HOWARD COUNTY HISTORIC PRESERVATION COMMISSION
ELlicott CITY HISTORIC DISTRICT ■ LAWYERS HILL HISTORIC DISTRICT
3430 Court House Drive ■ Ellicott City, Maryland 21043

February Minutes

Thursday, February 3, 2022; 7:00 p.m.

Figure 2 - Proposed new carport with gable roof.

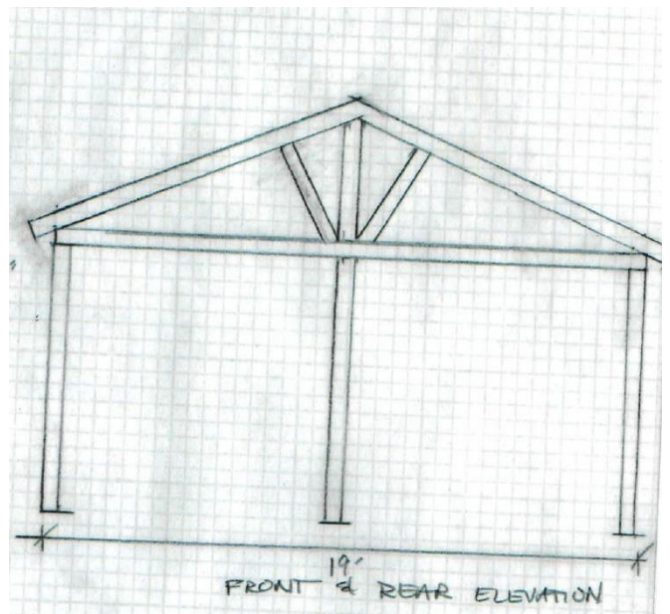
The new carport will match the existing in color and material, however the roof will be changed to a gable roof (currently a sloped flat roof), which will be more compatible with the gable roof on the historic house.

Testimony: Mr. Reich wanted to discuss the application. Mr. Shad swore in Ms. Larkin. Mr. Reich said the drawings were not very detailed. Ms. Larkin explained it is a very simple structure and will just consist of the 7 wood posts, with a gable shingle roof. She said she will paint the posts cream white to match the trim on the house. Mr. Reich asked a few questions to clarify the application, such as the location of the carport behind the house. Ms. Larkin said the building will be behind the house and will be difficult to see when driving down the road. Mr. Reich asked if the other Commission members had comments. Ms. Flynn Giles questioned whether or not they needed to make a determination of Unusual Importance. Ms. Holmes explained that because this was on consent, they could use the suggested motion to make that determination.

Figure 14 - Proposed addition to cover entire rear of structure.

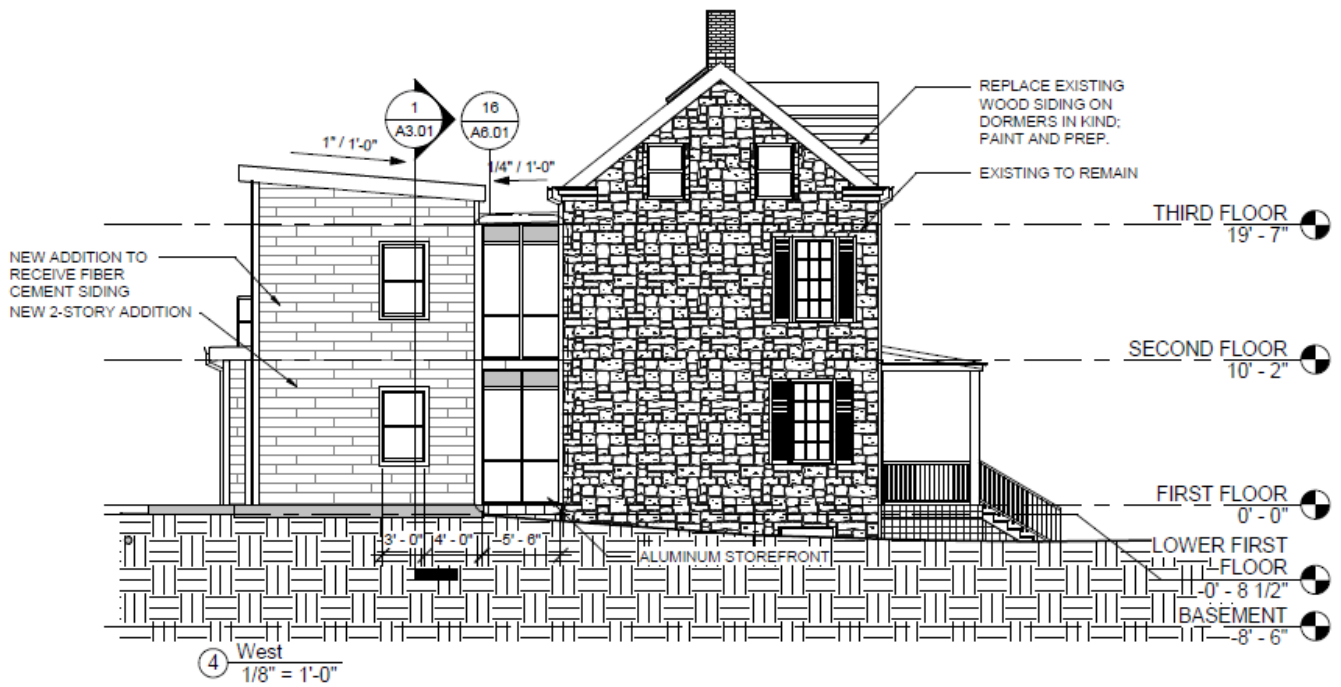
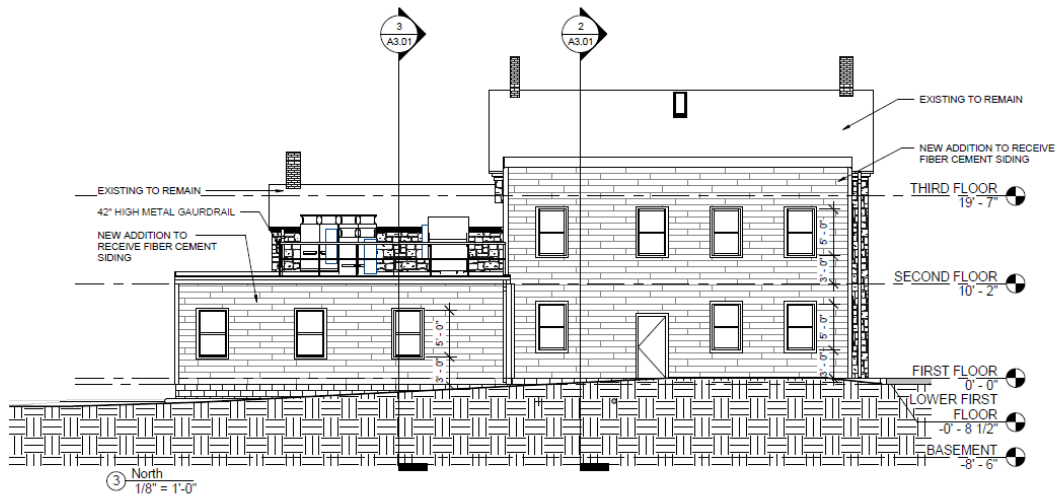
The proposed addition seeks to make clear what is historic and what is new by using the glass and aluminum storefront windows to connect the modern addition with the historic building.

According to the Applicant, the proposed addition is intended to occupy the general footprint of the existing addition; however, will be two stories tall behind the three-story main portion of the historic structure and one-story tall behind the two-story portion. Per the drawings, the proposed addition appears to cover the entire two-story rear of the historic stone building, obscuring parts of the rear of the building that have previously not been obscured. Also, per the Applicant, a portion of the one-story addition extends past the east side of the historical structure, similar to the demolished modern addition, but is set back behind the rear wall of the two-story portion of the historic structure to minimize the visual impact of the building addition and prioritize the historic structure.

The proposed new addition has a sloped roof that is pitched toward the historic house. Neither the pitch of the roof on the glass section of the building nor is its connection to the historic building are clear.

The proposed addition features a two-story section of glass and aluminum storefront windows adjacent to the historic structure with one set of 1:1 windows in the main part of the addition on the west side view. The glass and aluminum storefront windows appear larger than the windows on the historic building. The HPC should advise if the windows on the addition are similar in size, proportion or arrangement to the existing windows.

Mr. Reich said the addition looked very large in comparison to the mass of the house. When he first looked at the side elevation and saw the glass area between the two, he thought there was a glass link separating the house from the addition, but he realized that was not the case and the addition would run the length of the house. He said a better solution would be to carve into the hill and build the addition into the hill, so it disappears and connect it to the house with a glass link. This would allow someone to walk around the historic house and see the original construction. Mr. Reich understood where they tried to match the size and spacing of the window fenestration using 1:1 windows. Mr. Reich suggested being compatible with the house in form, such as using a gable roof, and window fenestration or making it completely different. Mr. Reich said the addition needs to be separated from the house. Mr. Thompson explained their intent was to leave the stone wall visible on the inside. Mr. Reich said the only reason to not move the addition is because of the hill, but that if the addition is moved 20 feet back, they would only have to carve out four feet. He suggested making the addition one-story, pushed back into the hill. He said if the addition remains two-stories, it should be pushed further back with a

minimal connection to the existing house. He suggested using stucco or something flat for the new construction siding, against the texture of the stone.

Ms. Zoren agreed with many of the comments made. She said the massing of the addition was very imposing and felt larger than the original buildings, which overpowered the historic building. She said the eave lines were very deferential to the original design. On the rear elevation she explained the eave line is above the historic building and it should be subservient to the original house. She would like to see a version where the rear elevation is brought down so the gutter line and cornice on the rear of the historic house are visible and not hidden by the addition. She said the proposed two-story addition is a little questionable, but if the addition is kept at two stories, the original building should read from all of the angles. Ms. Zoren explained that on the west elevation, water and snow is being sloped and trapped against the historic building which could become an issue down the road and it could affect the structural integrity of the historic building. She said 1 ¼ slope on the proposed addition is not much, especially when trying to protect a historic building. She explained that snow will be trapped against the historic stone wall, window headers and other historic building elements. Regarding the massing, Ms. Zoren said that using the existing foundation is not the premises to go with but suggested an L-shaped addition. She said the back of the building is attractive with the stone and window detail. She would like to see the addition pulled away perpendicular to the building and not parallel.

Ms. Zoren pointed out that the north elevation is not quite symmetrical and the windows are not spaced equivalent. She said it needs to be one or another and right now looks like a mistake. She said it was hard to comment on material selections without seeing them. She said there are shiny modern panels, and many other different kinds, and she would need to see what they are proposing. She said the massing is problematic so she cannot comment on the architectural design as the massing is obscuring the building.

Figure 27 - Proposed walkway material, concrete gray variegated Nantucket Paver, Traditional Yorkstone.

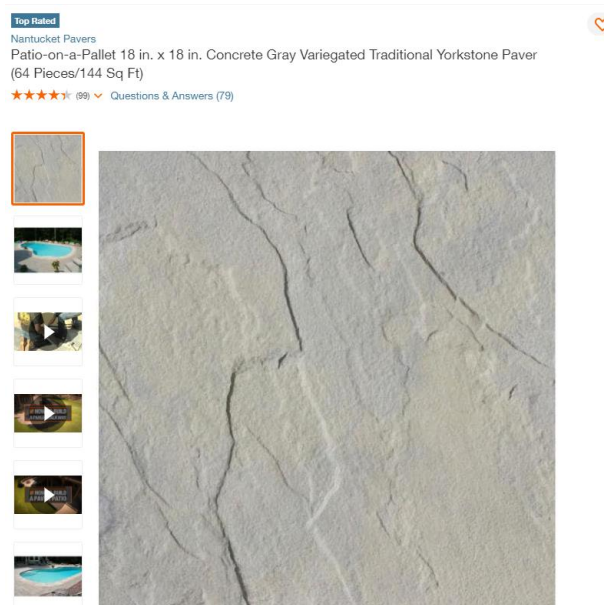
Mr. Shad said the paver walkway is fine, but they do not have any information regarding the size of the walkway. Ms. Danna agreed that she did not understand where the walkway was going. Ms. Feeney said it would be a two-foot walkway up to the deck. Ms. Feeney said the walkway might have steps, but they have not gotten to that level of detail yet.

Mr. Shad said they needed a plan showing this information and detail. Ms. Danna said the plan in the packet is not detailed and she would like to see a detailed site plan. Mr. Reich asked if the Applicant was willing to come back with more detail on the side deck.

Figure 33 - Windows proposed for replacement on Emory Street side of house.

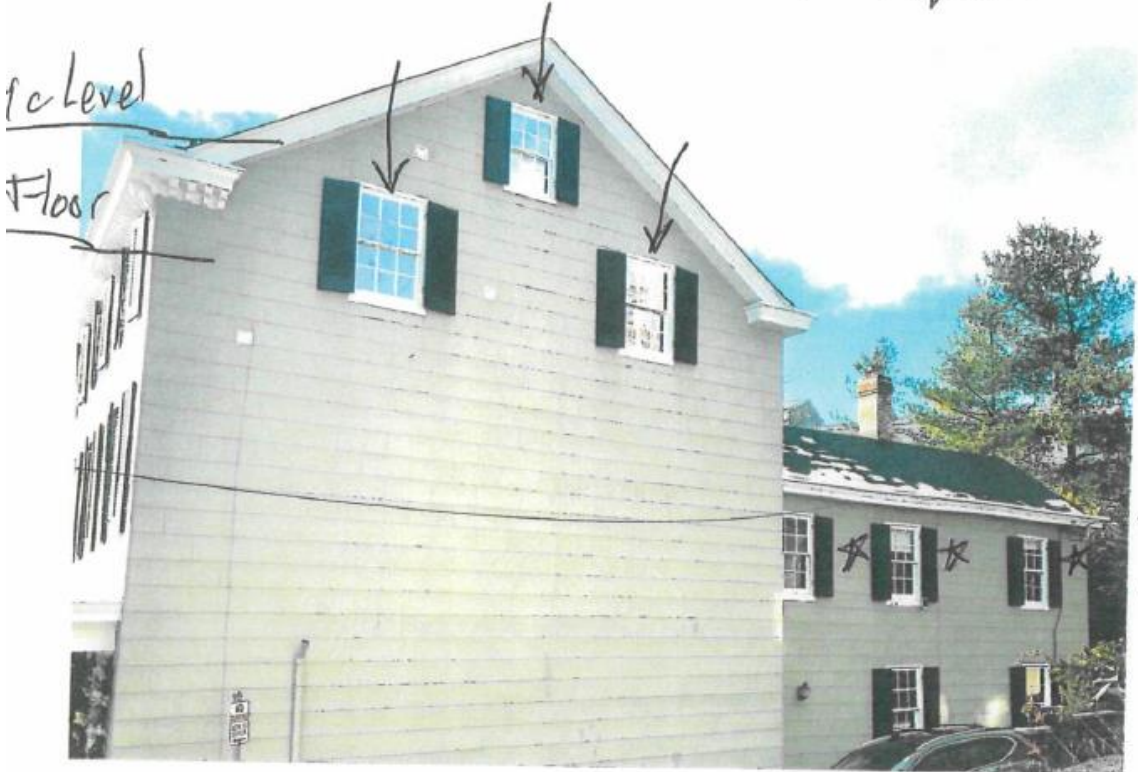
Ms. Zoren agreed with Mr. Reich's comments that the Guidelines do not allow to replace with metal or vinyl. Ms. Zoren said that replacing the windows with new wood windows would be a good option and they could approve tax credits for that. She said the new wood windows are supposed to last a long time and there should not be rotting and condensation with them.

Figure 36 - Proposed site plan showing location of house, driveway and sand mound septic system.

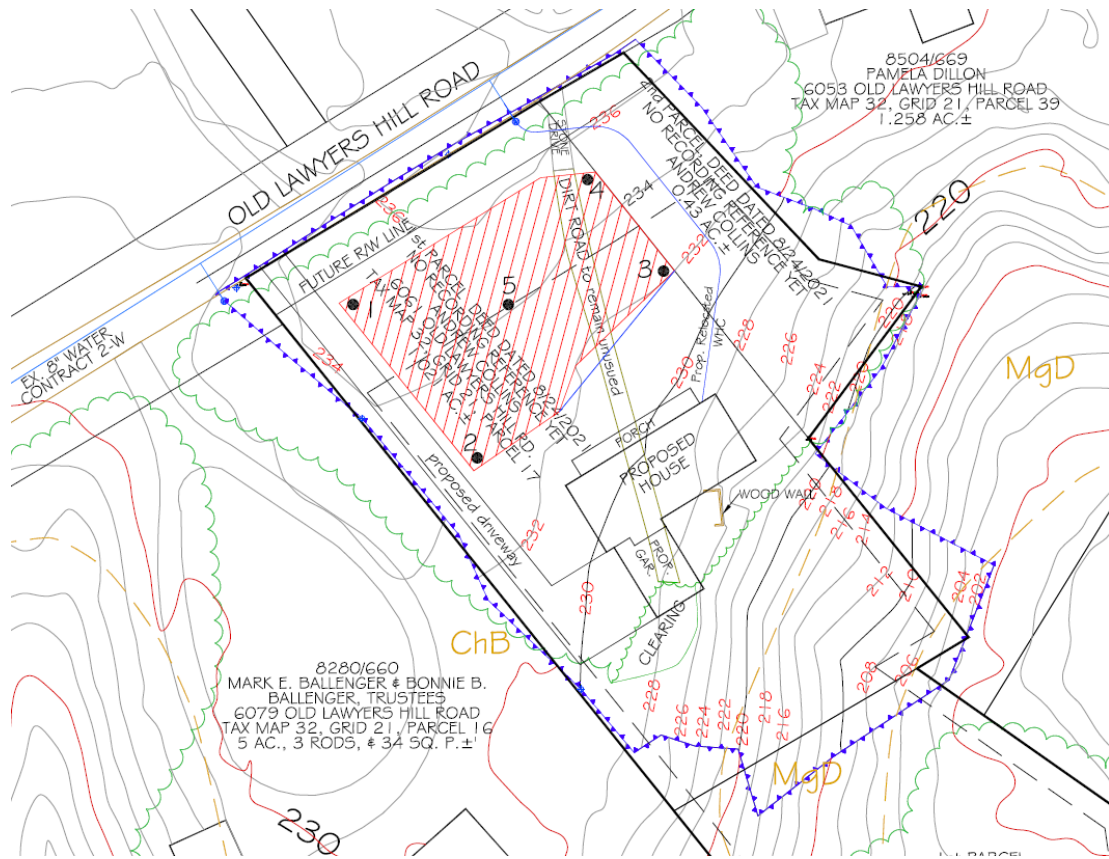
Because the land did not perc, a sand mound septic system, approximately 25’ wide x 75’ long x 3’ high, is proposed to be located close to the road. The extent of the limit of disturbance (LOD) this will cause to the existing landscape and trees is not clear. While the application states that approximately 11 trees will need to be removed, these are all located along the driveway and homesite. The application references landscape screening, but the specific shrubs, other plantings and surface treatment will be very important to properly screen the sand mound year-round and ensure that the historic integrity and natural setting of Lawyers Hill are maintained and comply with the Guidelines.

When the next application is filed for approval, it should include a plan showing a defined LOD for the septic system and home construction, in order to clearly see which vegetation will remain untouched and which trees, including their diameter measured at breast height (DBH), will need to be removed.

Ms. Zoren liked the site plan, the setback from the road and found the architecture fit in with the district. She liked the design of the garage, as it will not be visible until you get deep into the site. She said the front porch is very appropriate. Ms. Zoren said her biggest concern was the septic field; and the potential size, how vegetated the area currently is and how the field will be shielded from view.
